ADDENDUM #1

PROJECT NAME: SCCAD Headquarters

CLIENT NAME: St. Charles County Ambulance District

PROJECT NO.: 18007

Project No. 18007
 Sheet No. **A423**
 Date: 12/02/2019

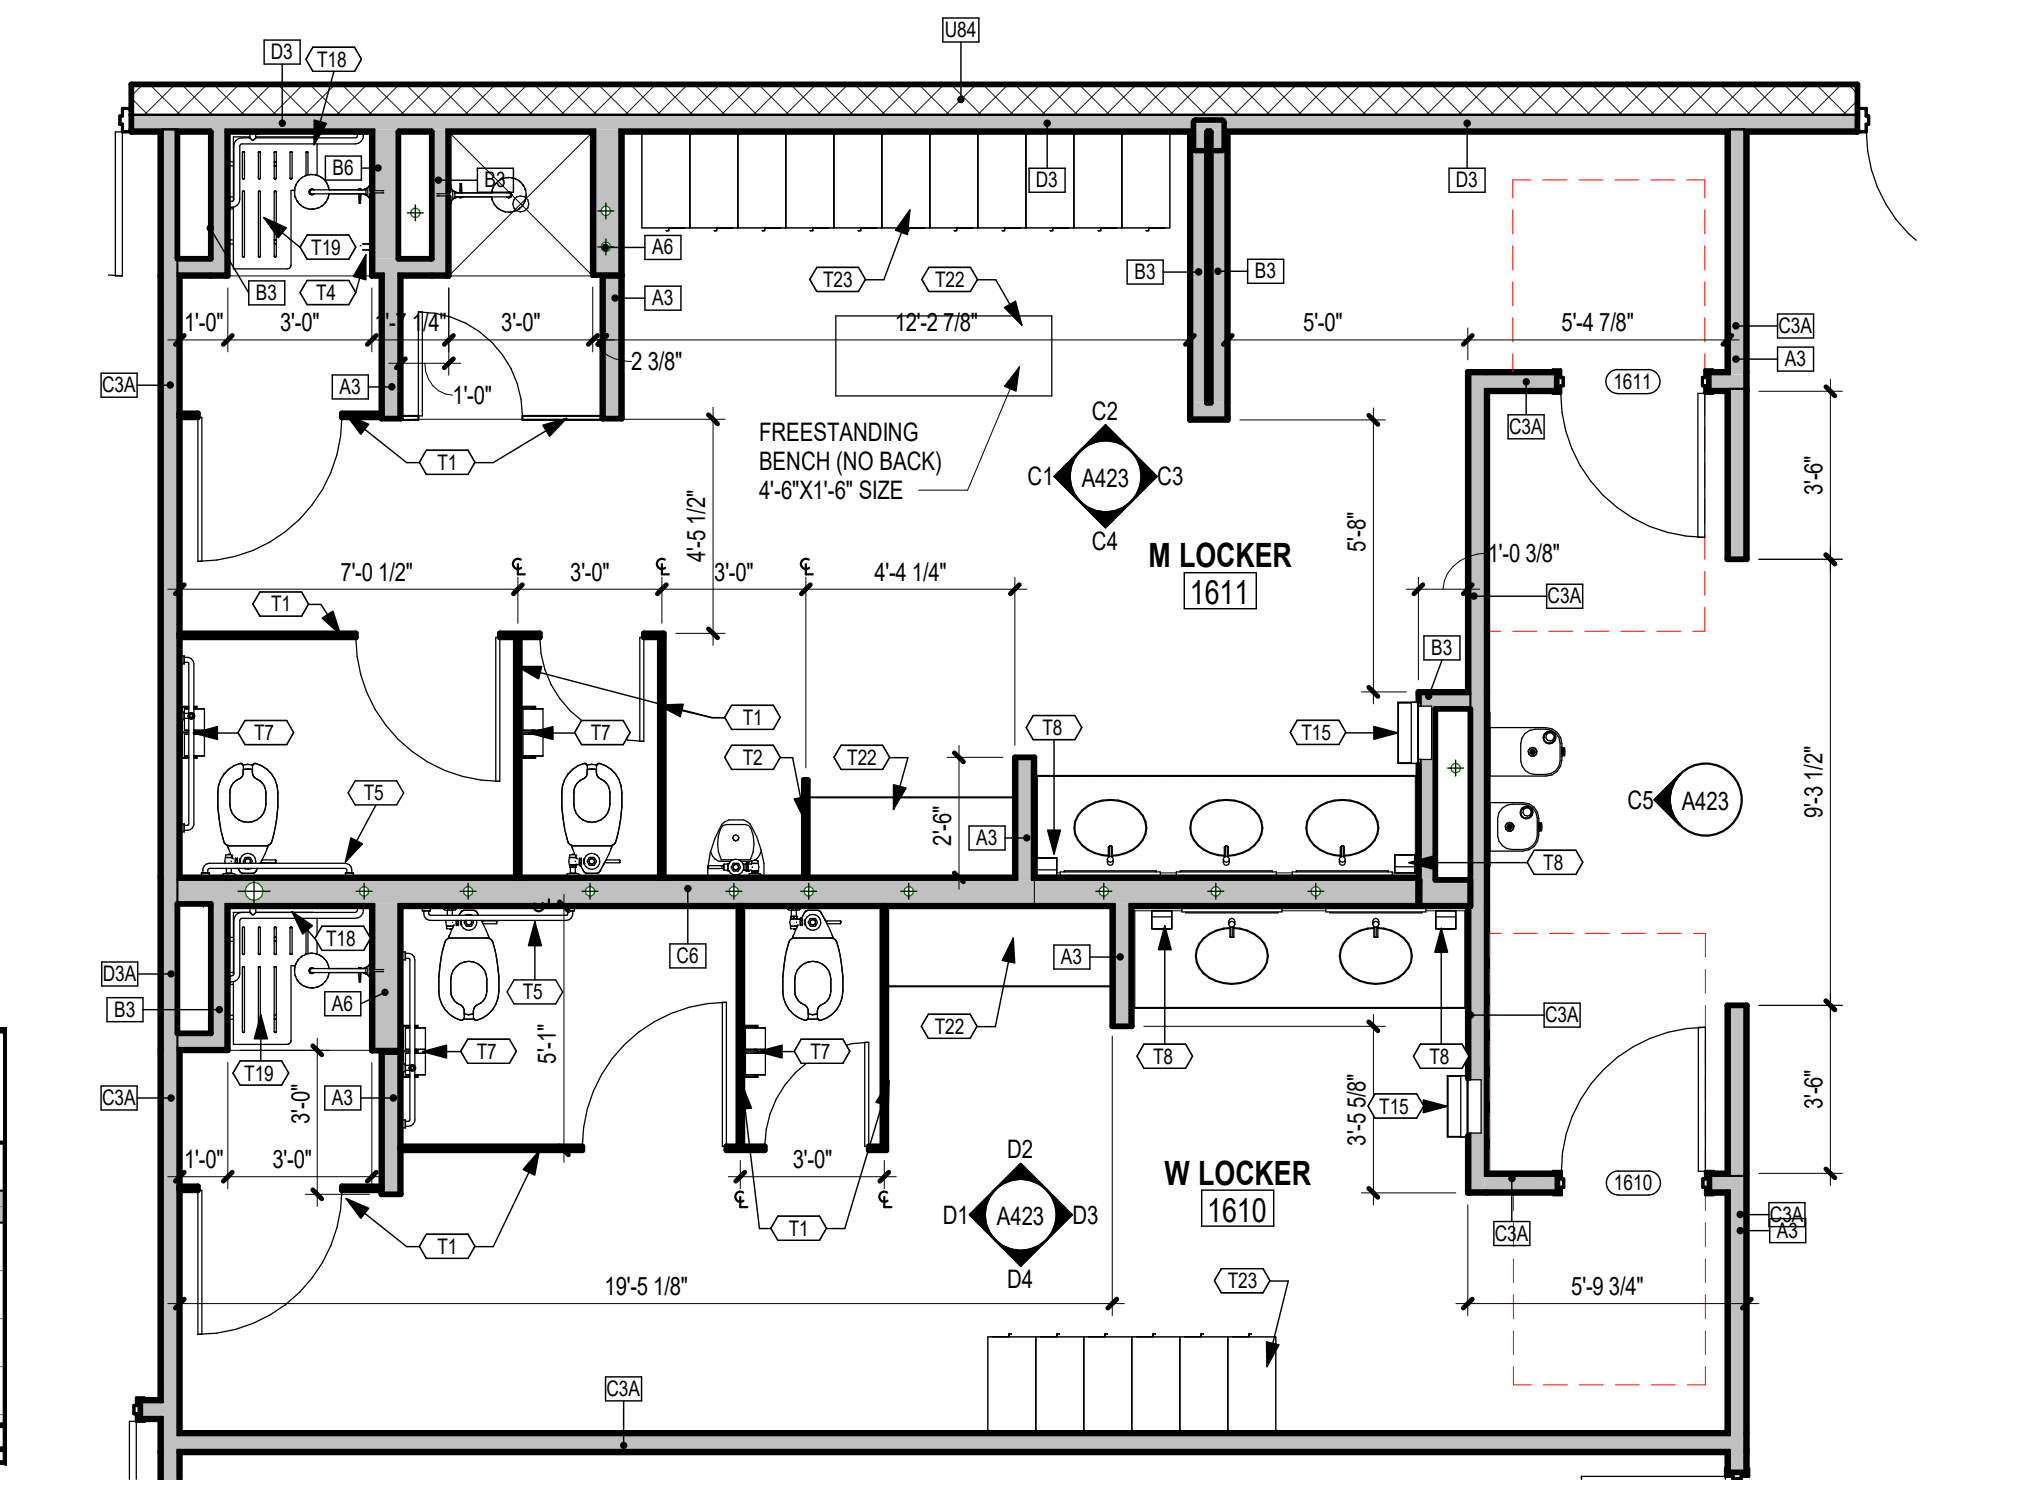
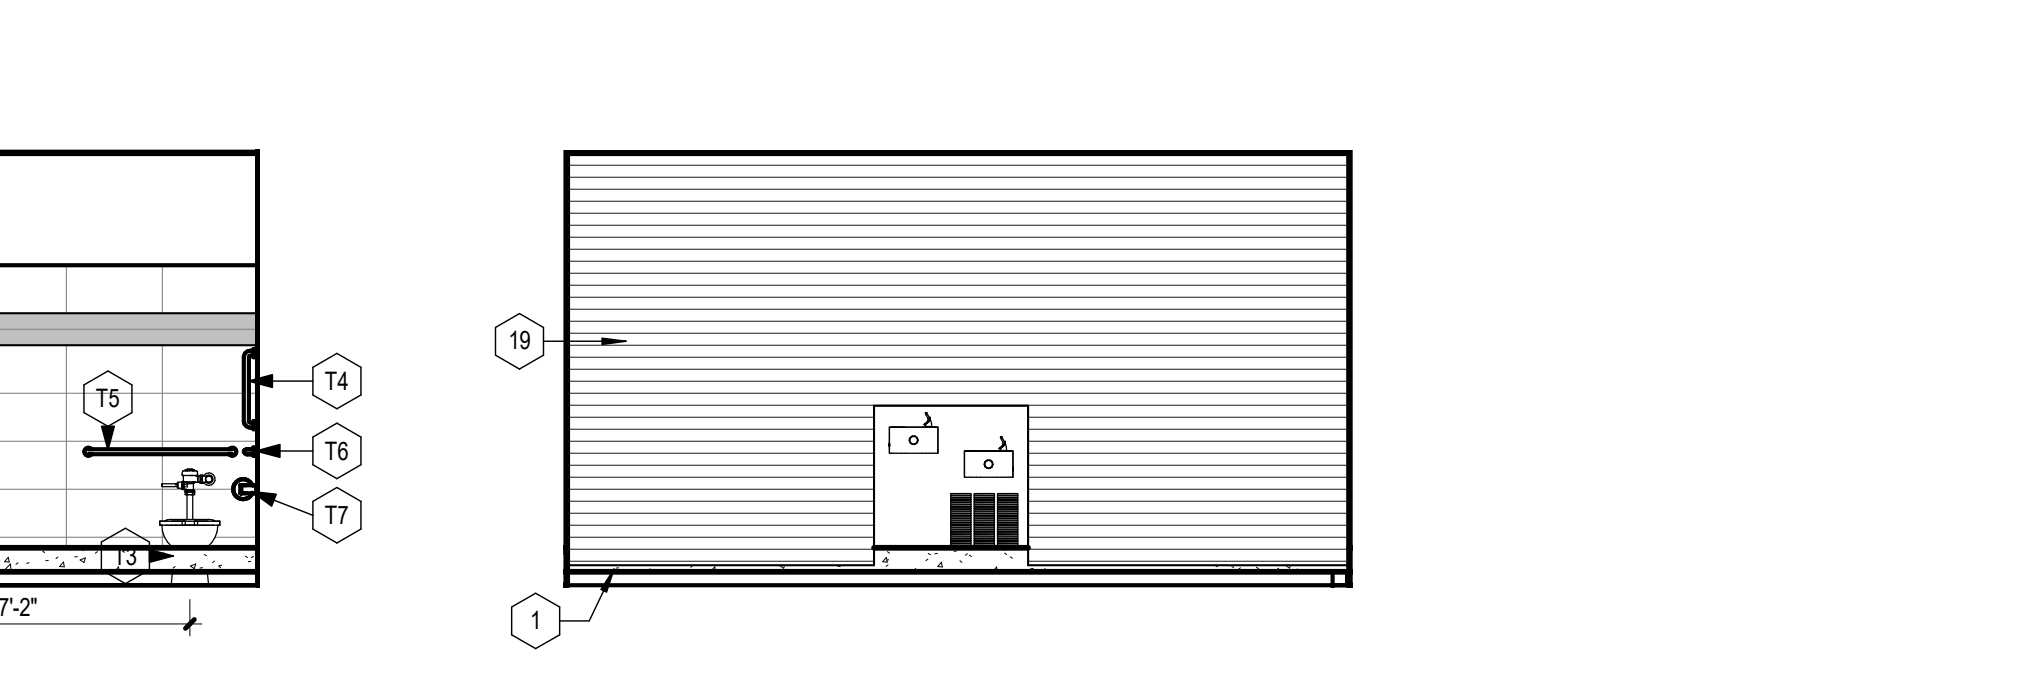
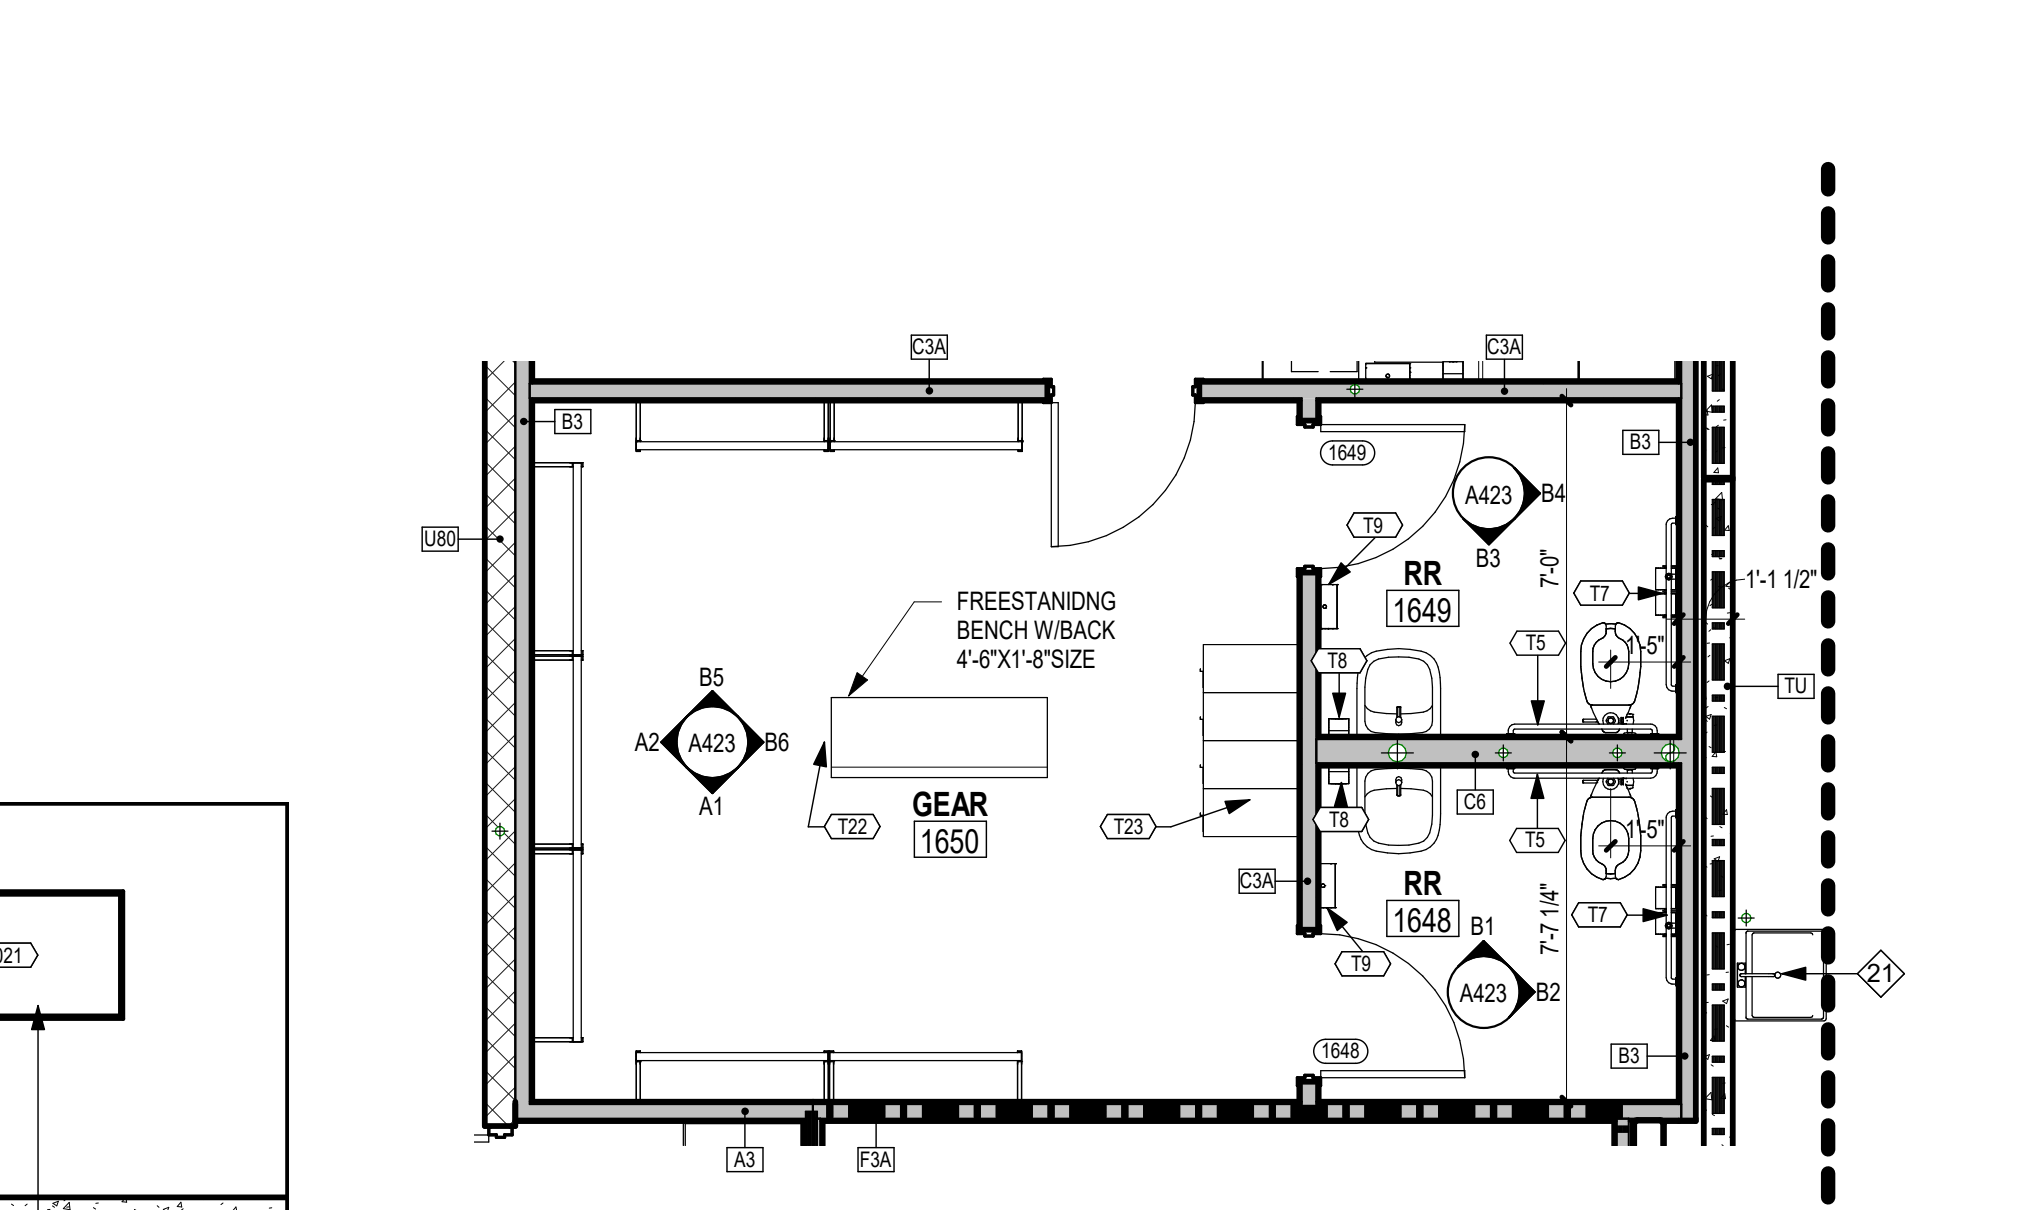
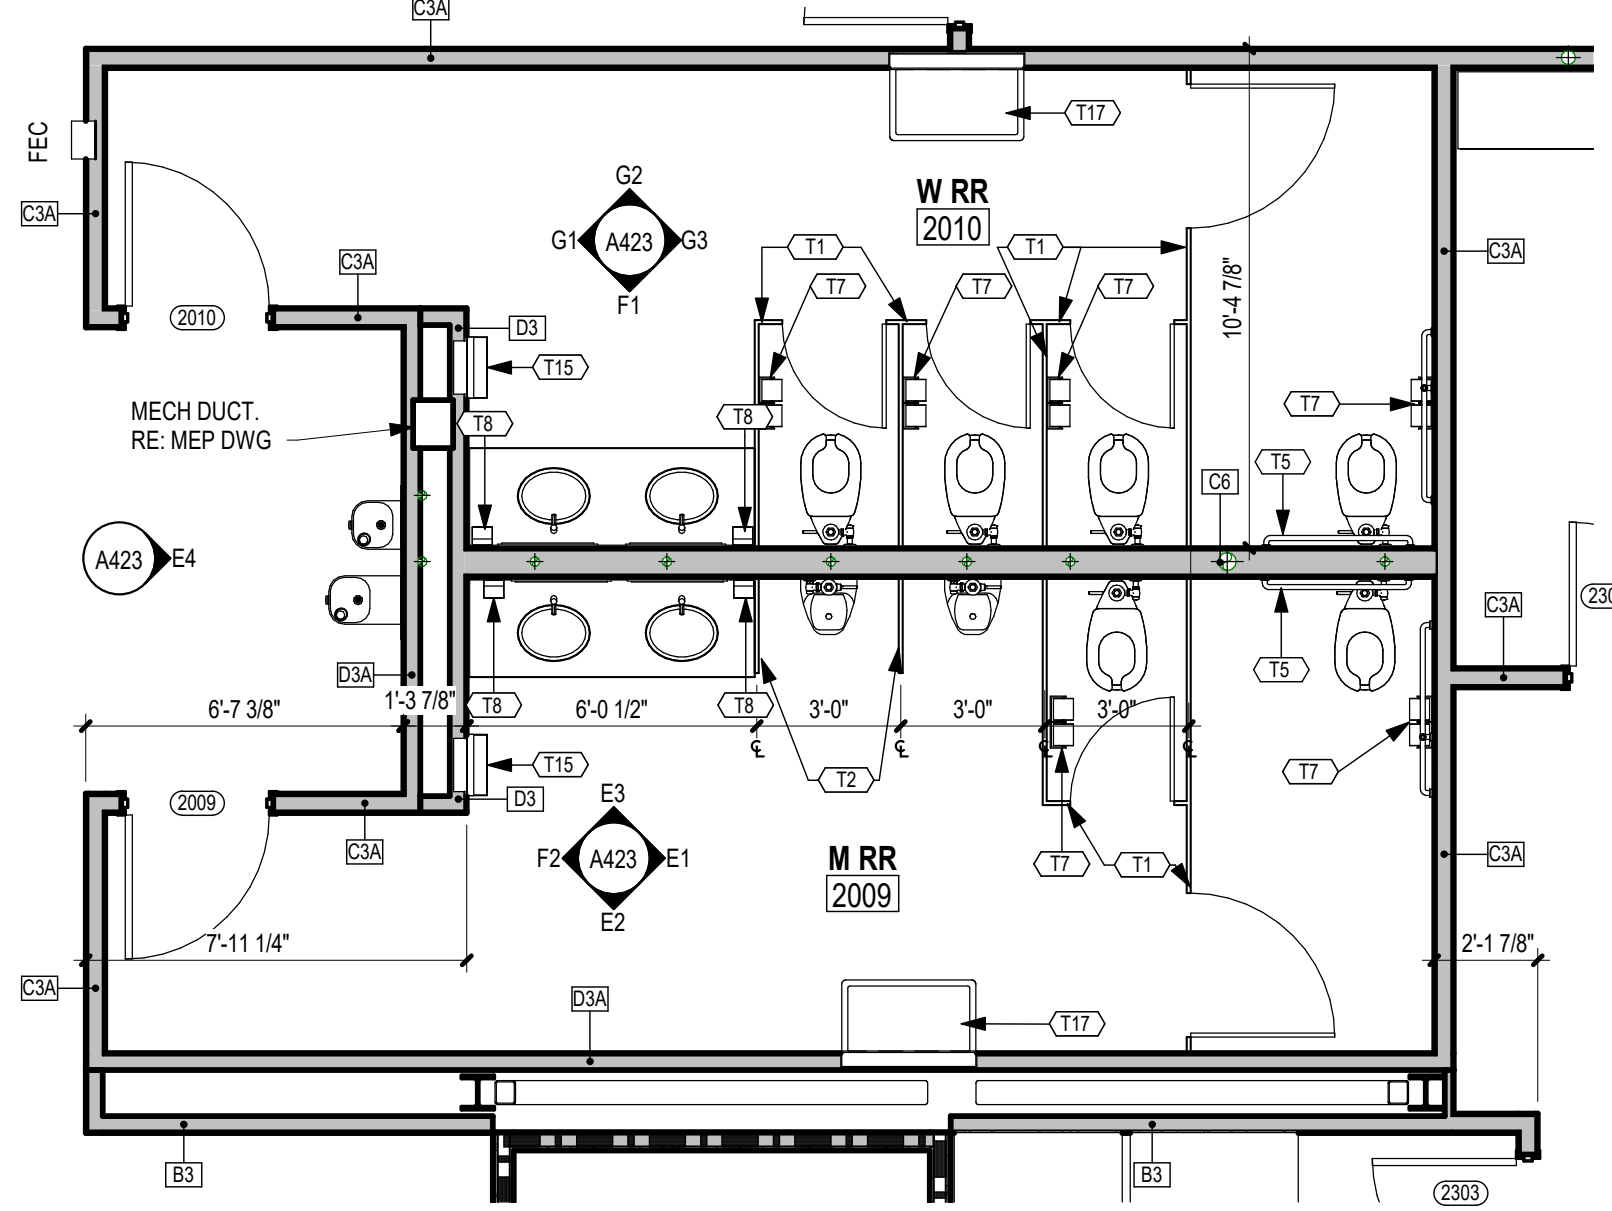
SHEET A423 – Toilet / Locker Plans & Elev.

1. ADD – Notes:
